Manuscript Number: NIMA-D-08-00031R1

Title: Extended-time-scale creep measurement on Maraging cantilever blade springs.

A revised version of the "Extended-time-scale creep measurement on Maraging cantilever blade springs" has been uploaded to Elsevier. Thank you for all of the useful comments. Each comment in the previous email was reviewed point by point and revised as suggested with the following exceptions and rebuttles:

Figure 8a  
[Click here to download high resolution image](#)

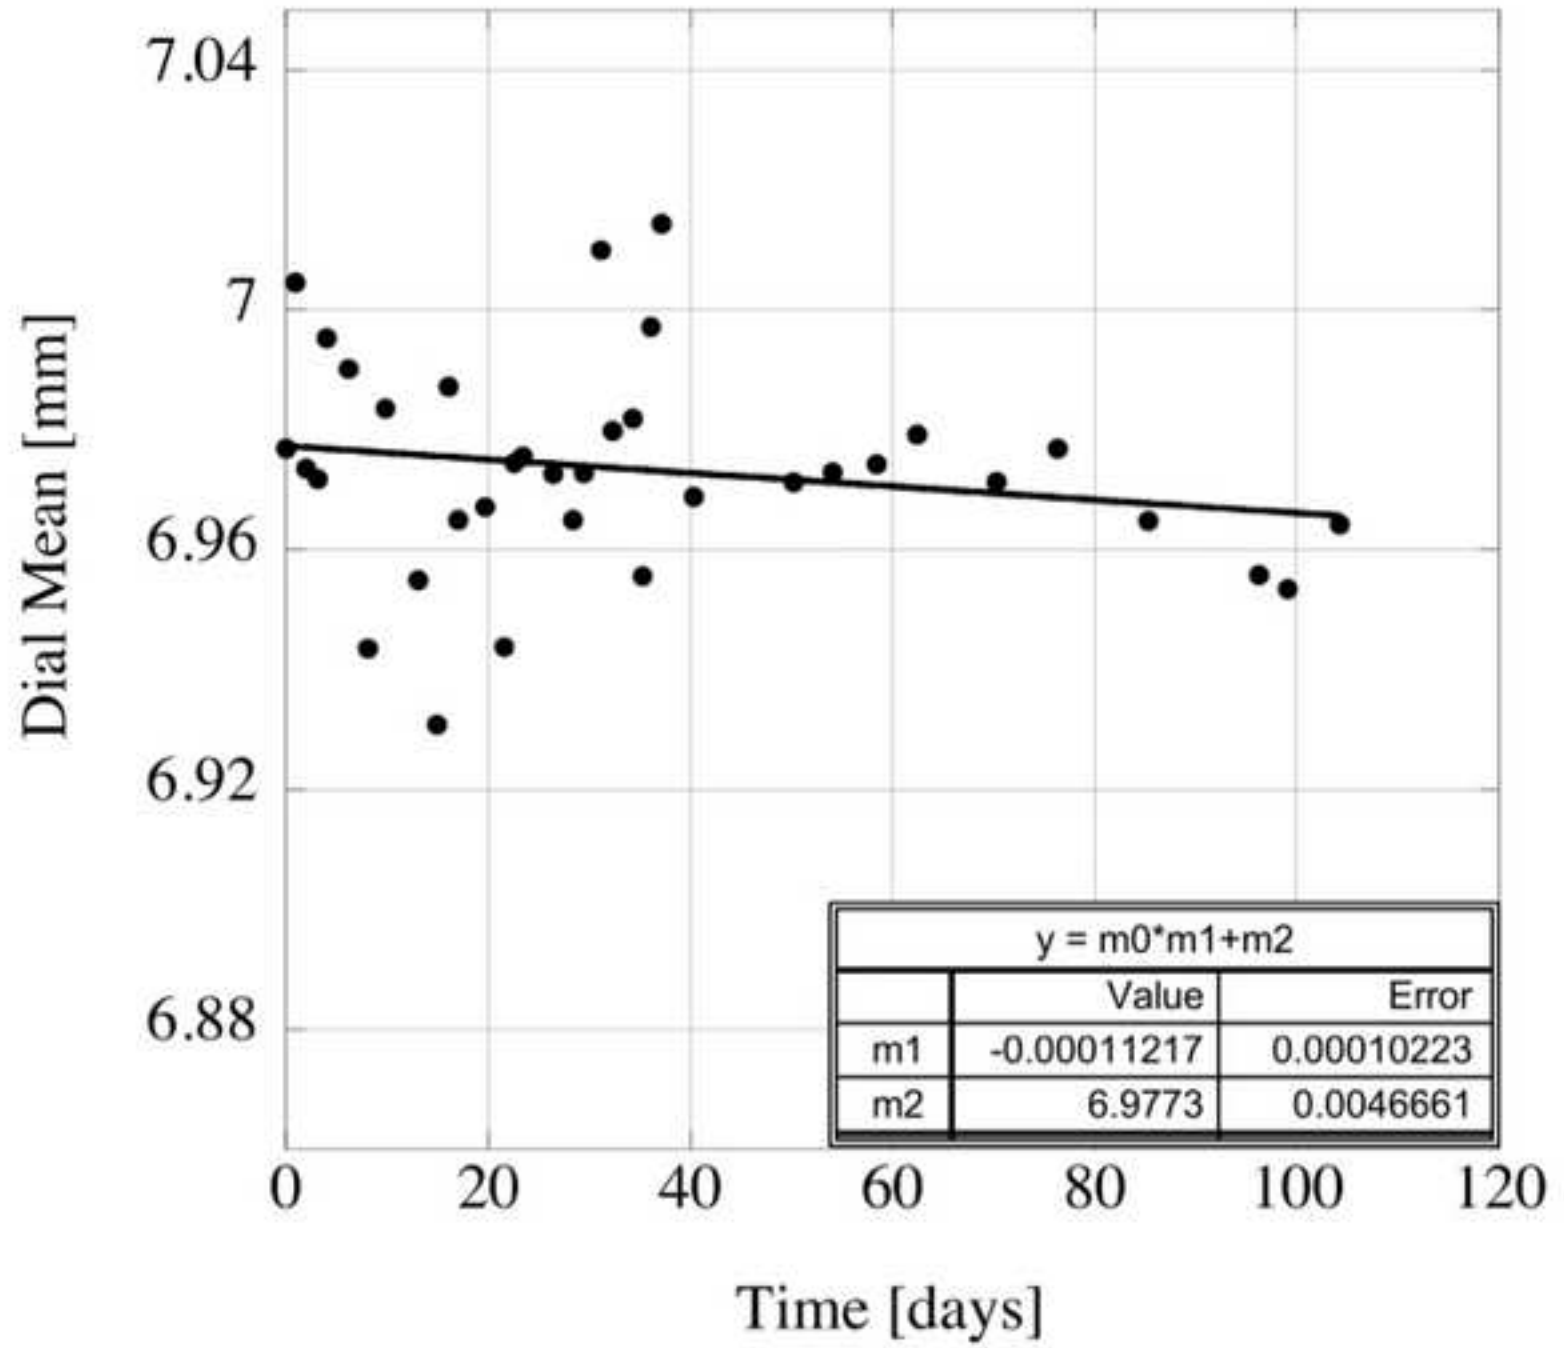
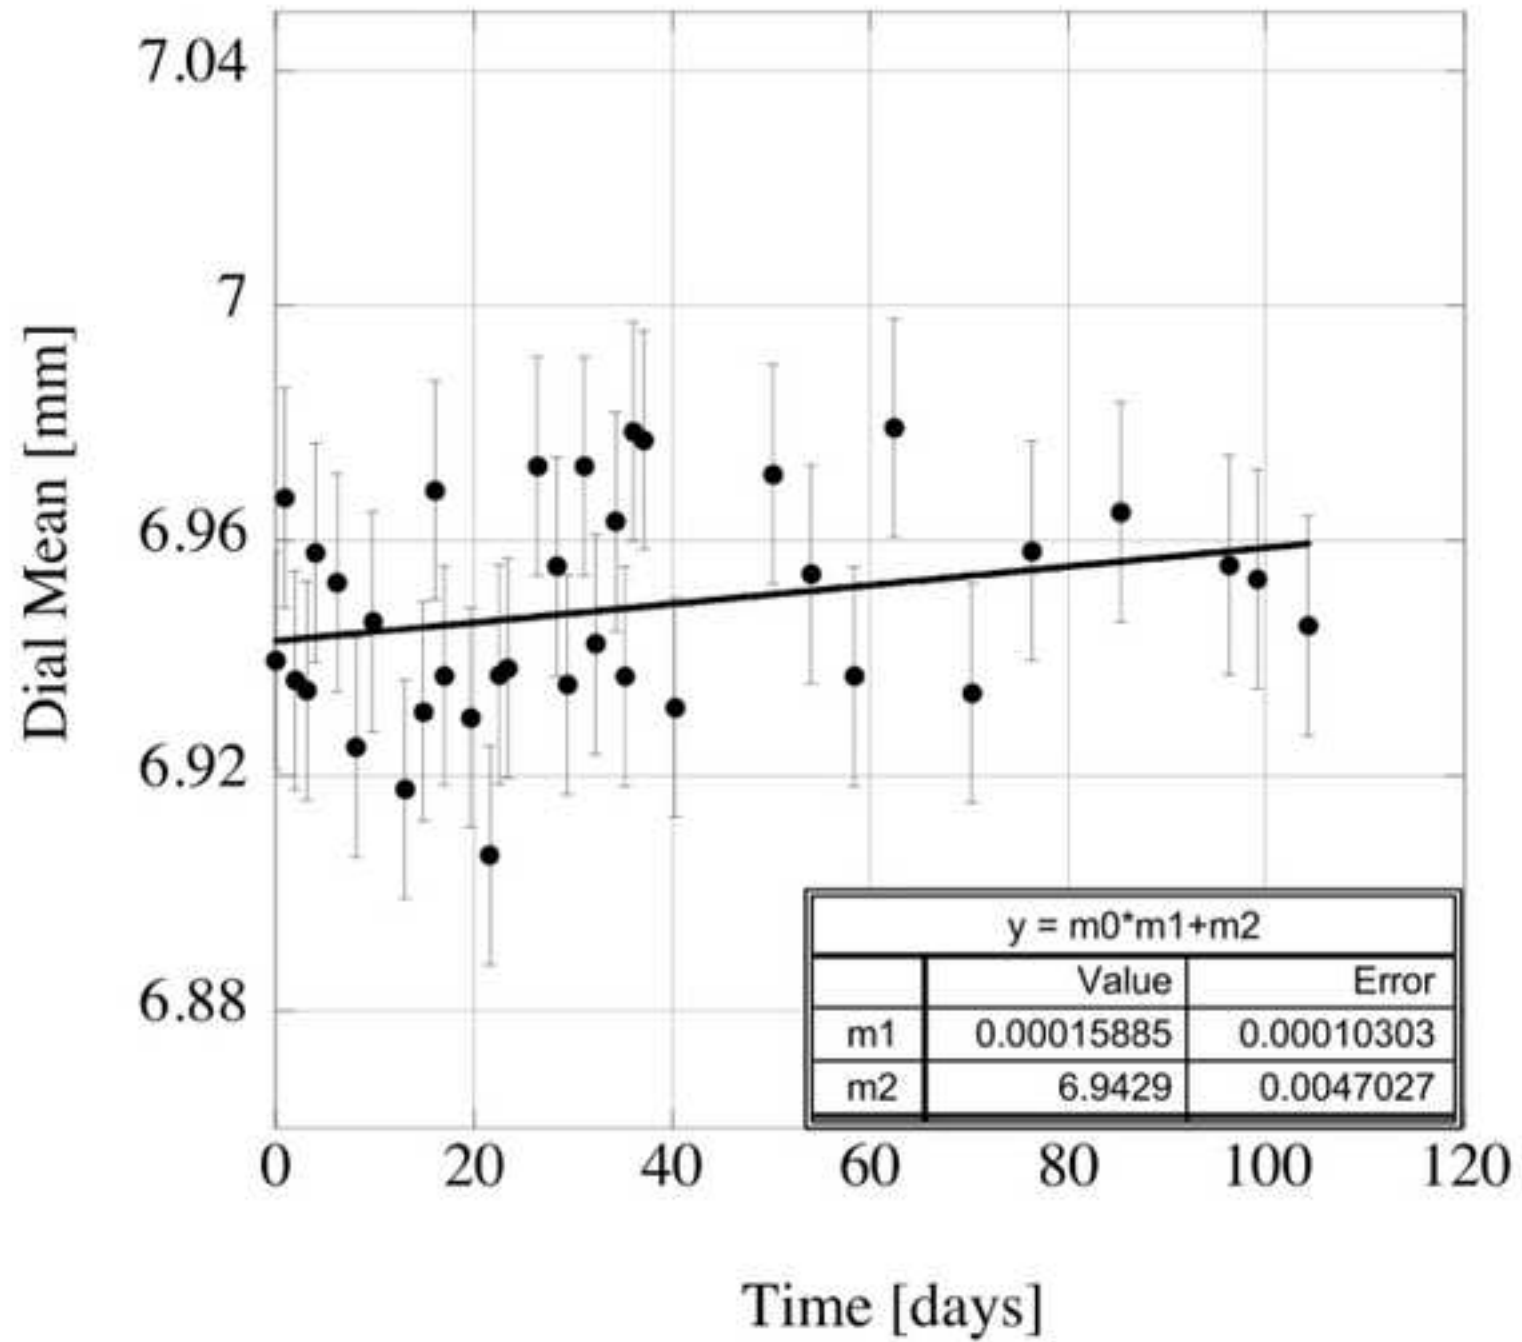
- In response to point 2, the formula is the Arrhenius thermal acceleration mentioned just above, we find it superfluous to repeat it in the introduction.
- In response to point 3, The key point in showing both graphs is to illustrate how the measurements are upper limits, still dominated by the systematics of the correction factors and compatible to zero. Note that applying our best estimated corrections the creep is actually negative (positive slope), which is obviously impossible but makes our claim of zero creep much more compelling. Also note that the raw measurement is only 1.1 standard deviations from zero, and the corrected one 1.5 standard deviations, but in the impossible direction.
- We believe that our claim that the creep is compatible to zero within our errors is a reasonable claim. Following your comment, though, we modified the caption from

"The fits in the two curves,  $-0.11 \pm 0.1$  mm/day for the raw data and  $0.15 \pm 0.1$  mm/day for the corrected data are both compatible, within our measurement errors, with no creep. "

to:

"The fits in the two curves,  $-0.11 \pm 0.1$  mm/day for the raw data and  $0.15 \pm 0.1$  mm/day for the corrected data are both compatible, within our measurement errors, with no creep. The opposite sign of the two slopes indicated that the measurement is dominated by systematics."
